**Well Name:** SAN JUAN 30-6 UNIT

**Well Number:** 138

## Subsequent Report

CASING REPAIR (INT/PROD CSG COMM)

## Current Schematic - Version 3

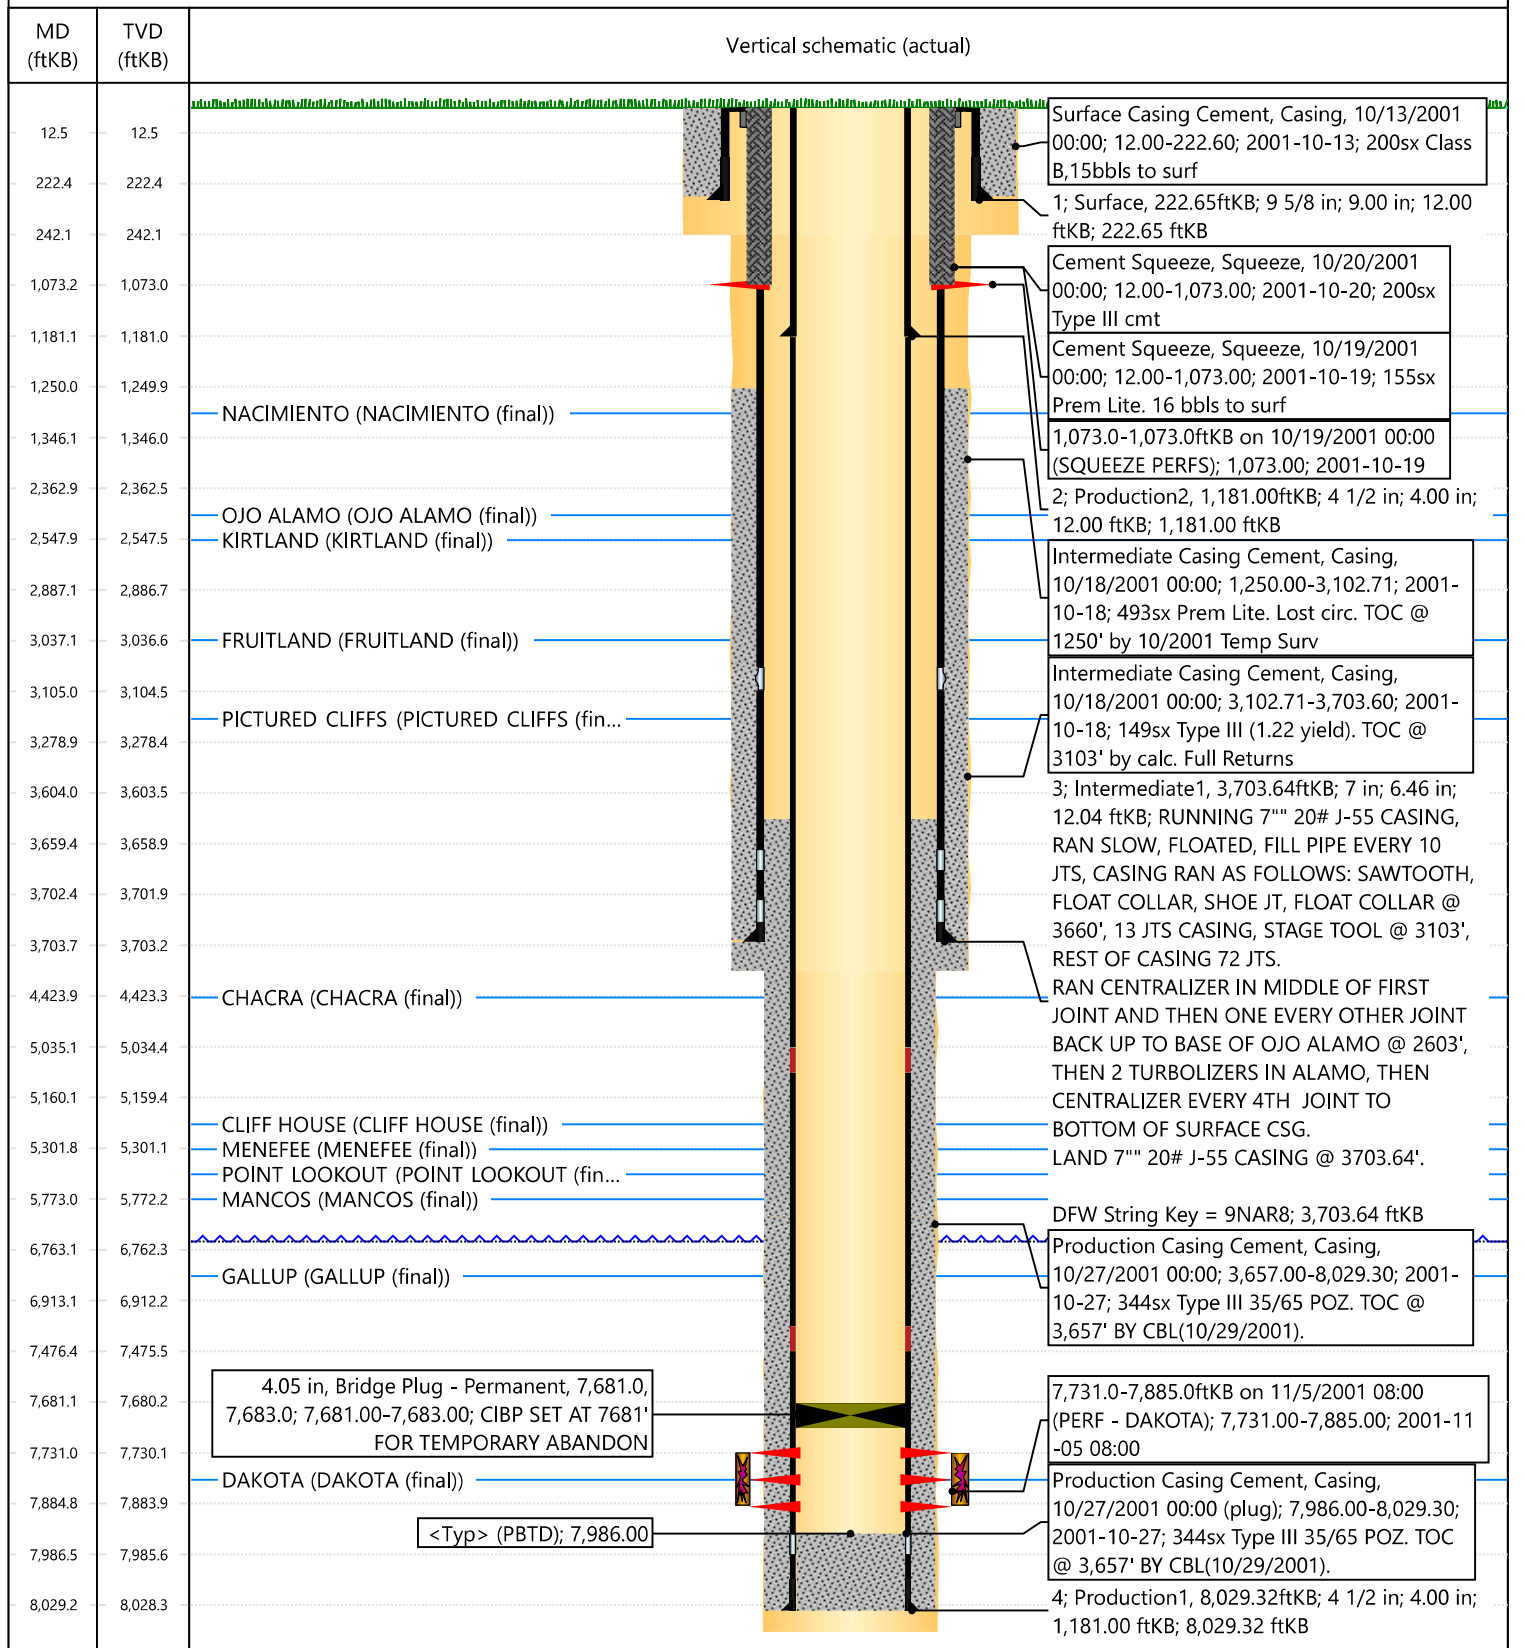
Since I cannot read the schematic in well file (please provide as indicated by BLM below an updated wellbore schematic that is readable)- Removing tubing and setting a cibp at 7681, which appears to be 50 feet above top perforation? , I approve that but need verification on top perf prior to setting cibp. Testing the production casing for TA from 7681 to surface I also approve.

However, this is a bradenhead repair dealing with communication between intermediate and production casing. To go into temporary status the intermediate issue would have to be resolved. Bradenhead testing would need to be performed 30 days after rig move 6 months after rig move and 1 year after rig move. If the intermediate/bradenhead problem has not been resolved then Hilcorp will have to move back on immediately if any of the 3 tests fail.

Please see the current schematic attached. The top Dakota perforation is at 7,731'. The proposed plug depth of 7681' is 50' above the top perforation.

Fixing the production casing should resolve the intermediate issue/shut off the communication between the production and intermediate strings. We will ensure that the intermediate issue is resolved, and approval is received prior to rigging down.

The BLM finds the proposal appropriate. Please submit a subsequent report describing the work completed and the steps to prepare the well for temporary abandonment. Please include an updated wellbore schematic.

And submit a separate notice of intent requesting the temporary abandonment status. Provide the effective data and the proposed expiration date. The expiration date cannot be greater than 12 months.

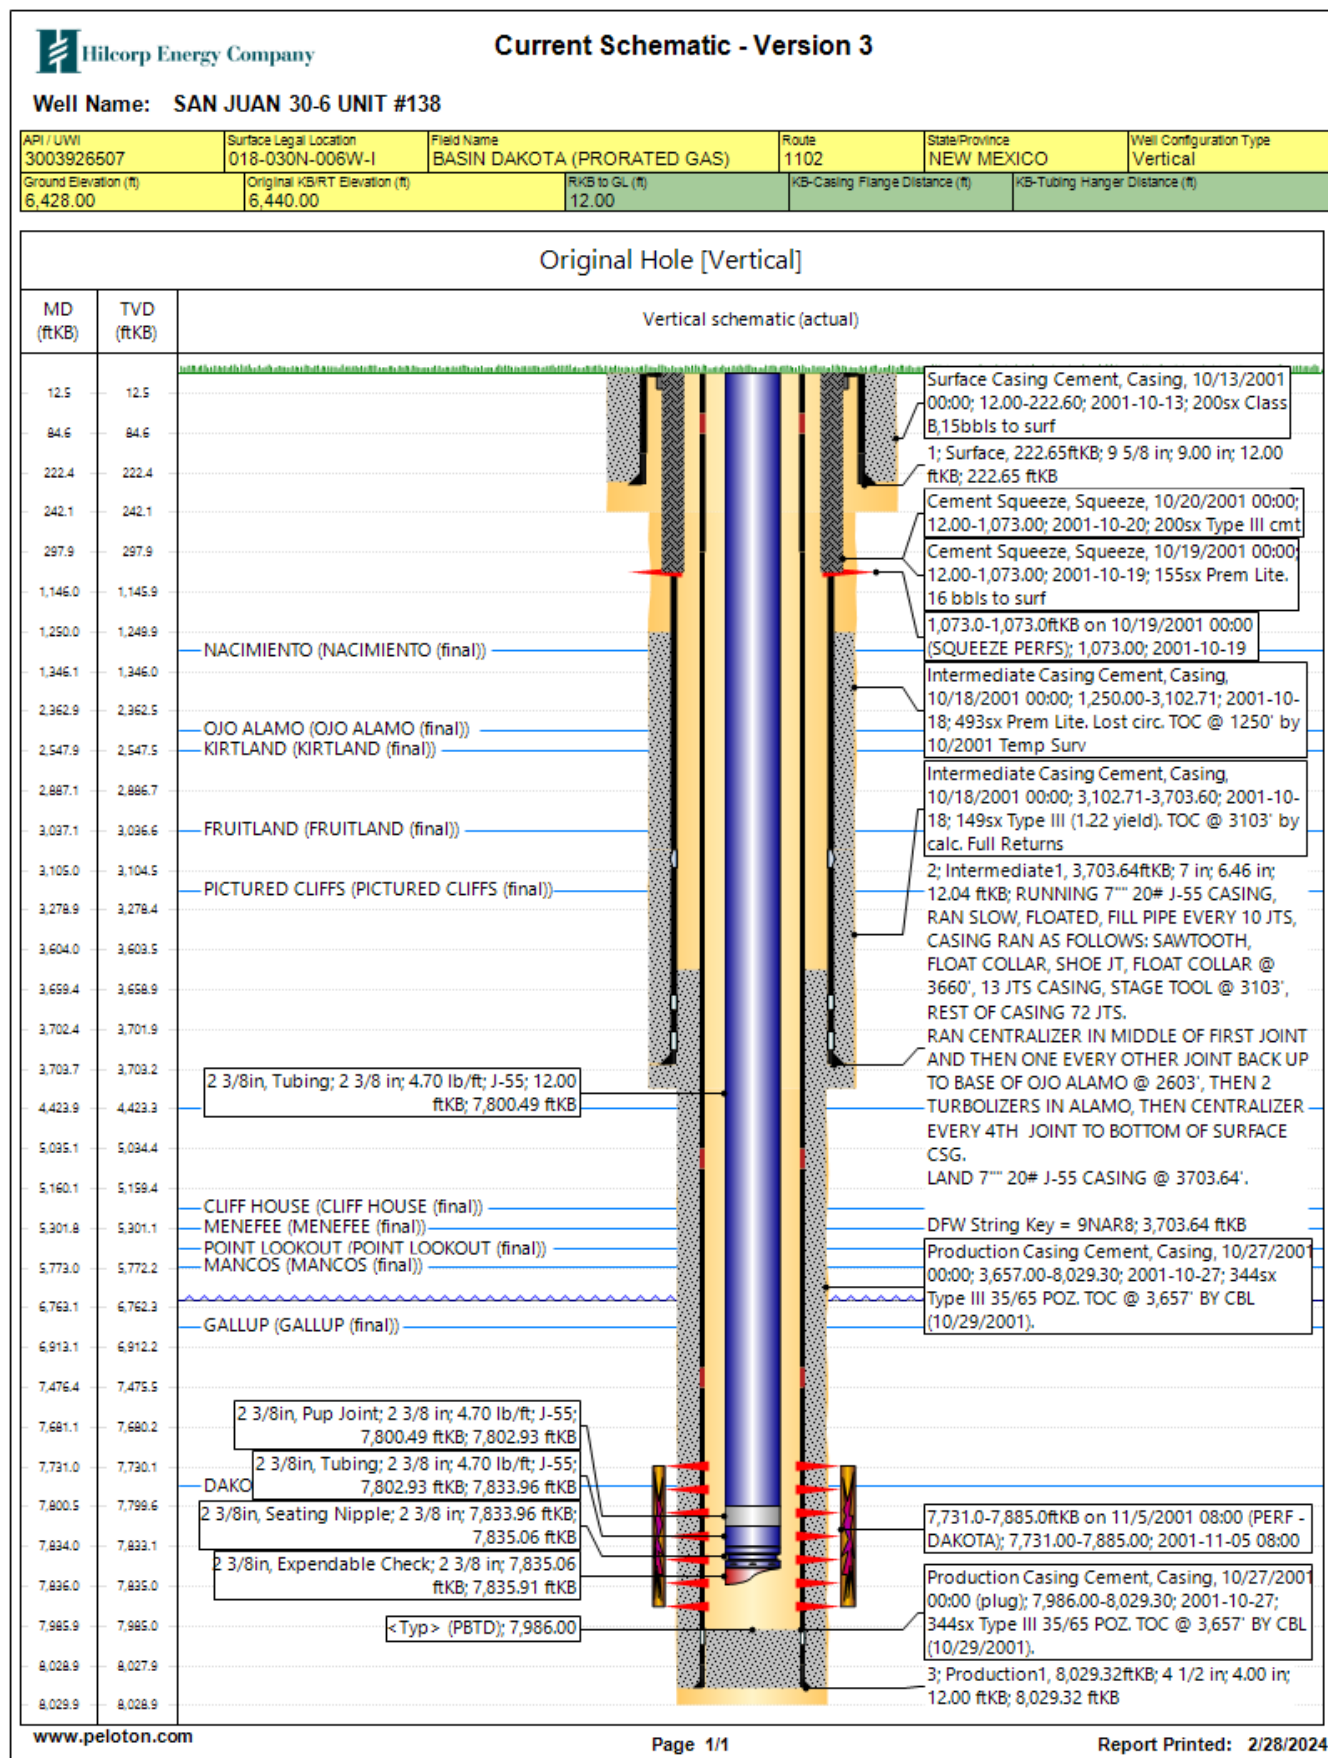
Regarding the San Juan 30-6 Unit 138 casing repair – when we rigged up on the well and attempted to pull tubing, we found that the tubing was parted (~400 from surface). We recovered 403' of tubing. We then attempted to run in with an overshot to fish the remaining tubing. However, we were unable to get down with the overshot due to what we believe to be parted casing. The casing part is in the 4-1/2" and is at +/-52'. To remediate - we will recover the parted casing above 52', then back off the casing a few joints below the part, run a cut lip guide shoe, and screw back in with new 4-1/2" casing. We'll run a witnessed MIT once complete.

The schematic is below for reference. Please let me know if you have any questions.

- schematic unreadable when enlarged - monitor string pressures daily. Notify NMOCD prior to any cementing. Notify NMOCD 24 hours prior to testing.

NMOCD approves below – this is a compliance for intermediate/production casing direct communication.
